MAJOR PROJECT ASSESSMENT:
Studio and Office Complex at the
Australian Technology Park,
Eveleigh.

Modification MP 06_0149 MOD 1.

Modification of Minister's Approval under
Section 75W of the *Environmental*
Planning and Assessment Act 1979.

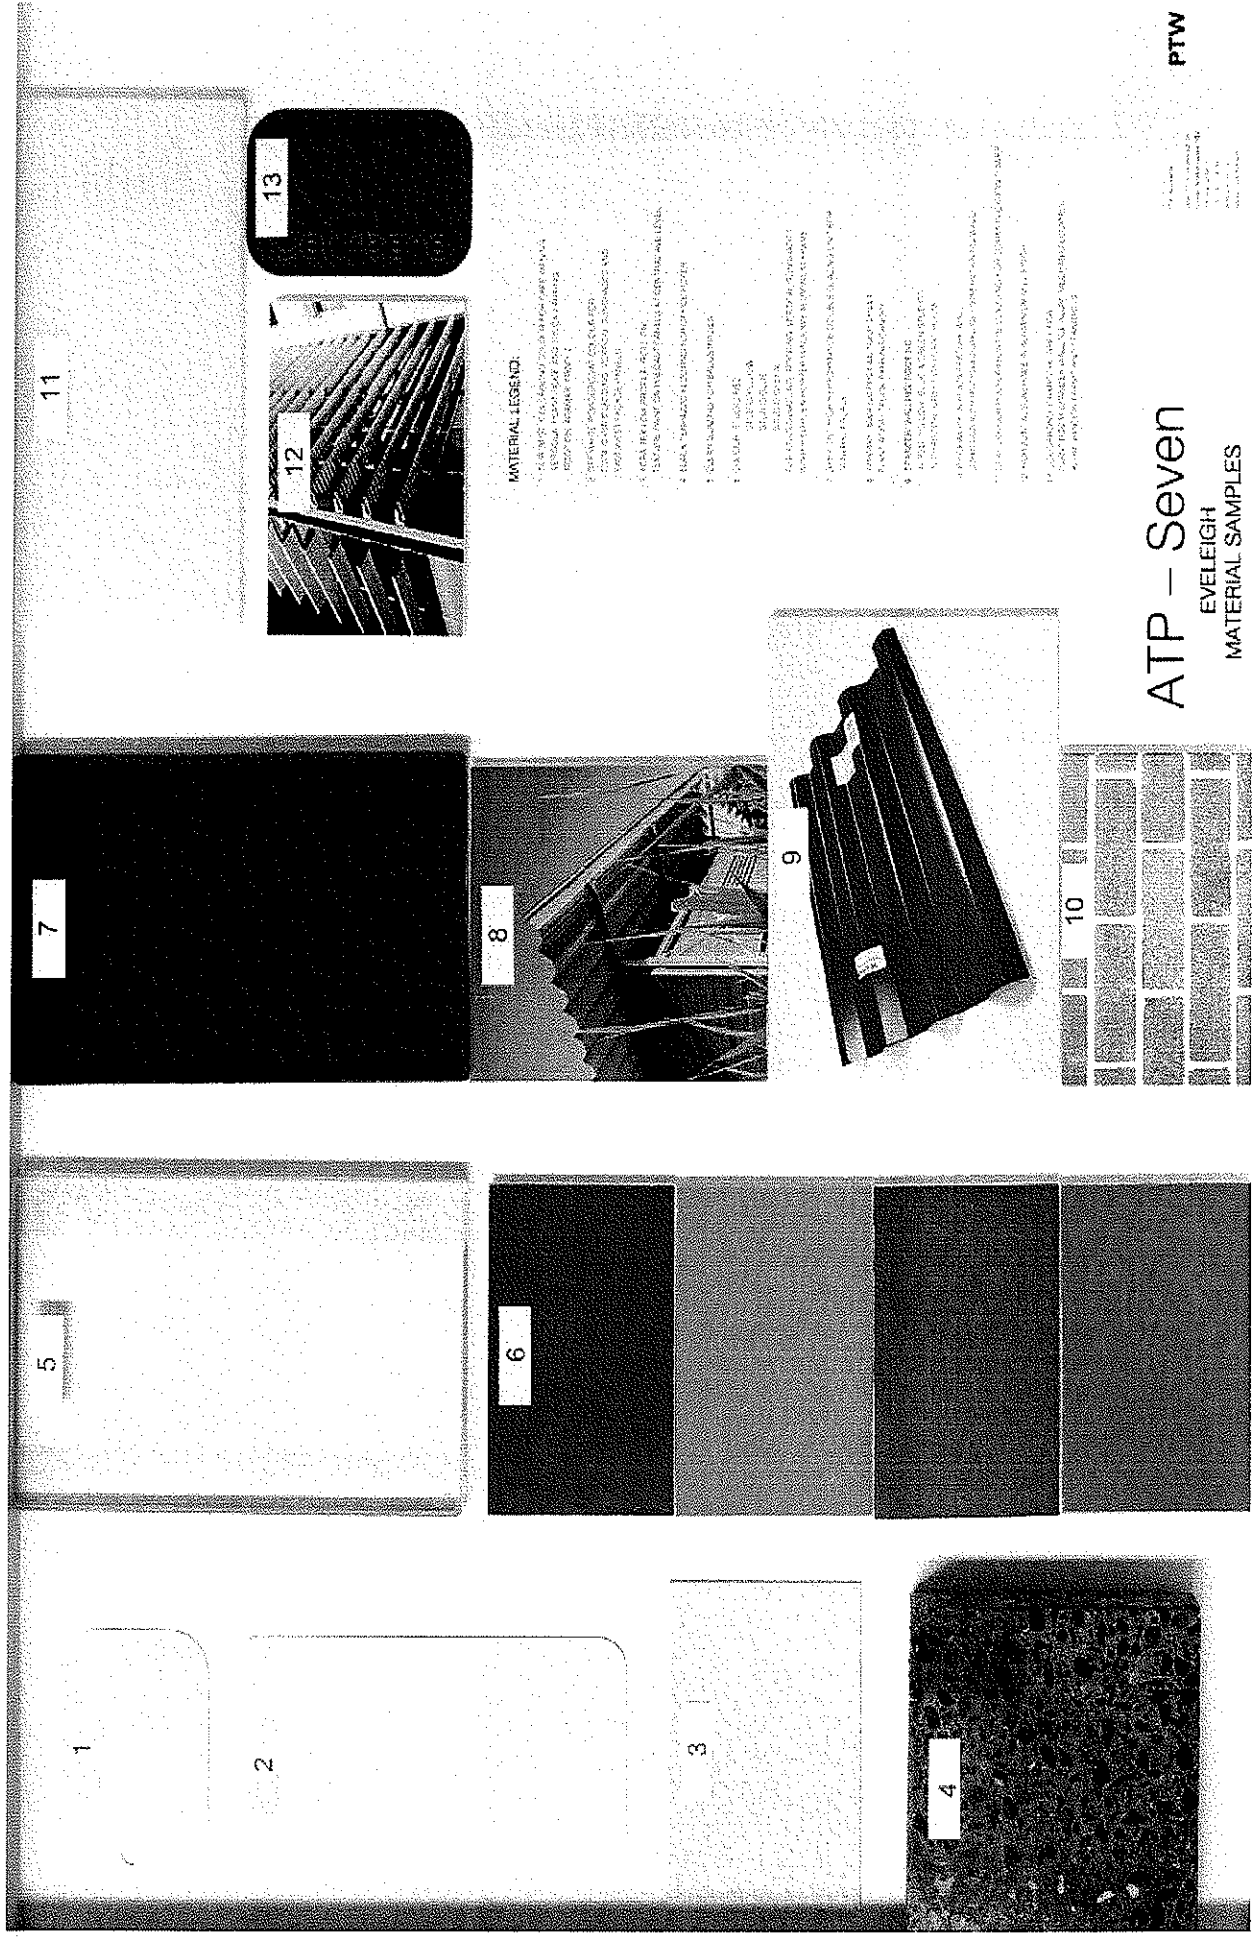
A proposed Materials and Finishes Board has been provided, depicting several revised external finishes for the building to those specified in the approved Materials and Finishes Board. Modifications to the external finishes include aluminium balustrades to replace the approved glazed balustrading to Level 5 roof area, and replacement of the upper portion of the public domain brickwork feature wall with a precast concrete panel.

The revised Materials and Finishes Board also provides additional details including:

- Part vergola operable louvers proposed for café awning and part of façade awning;
- Zincalume based cladding for north-facing elevation to studio plant, as well as all facades on Level 12; and
- Vitrabond aluminium panels for spandrels and window frames for all facades (grey-matte finish to north and south elevations, off-white matte finish to east and west elevations).

The originally approved Materials and Finishes Board and the revised Materials and Finishes Board are depicted in Figures 3 and 4, below.

The Department has reviewed the amended Materials and Finishes Board and considers the amendments to be minor in nature, and will not alter the overall appearance of the building, nor does it alter the relationship of the building to the nearby heritage items. The Department is satisfied that the amendments will continue to ensure an appropriately high standard of external finish to the building.

Condition A2 – Development in Accordance with Plans, will be amended to reflect the amended Materials and Finishes Board.
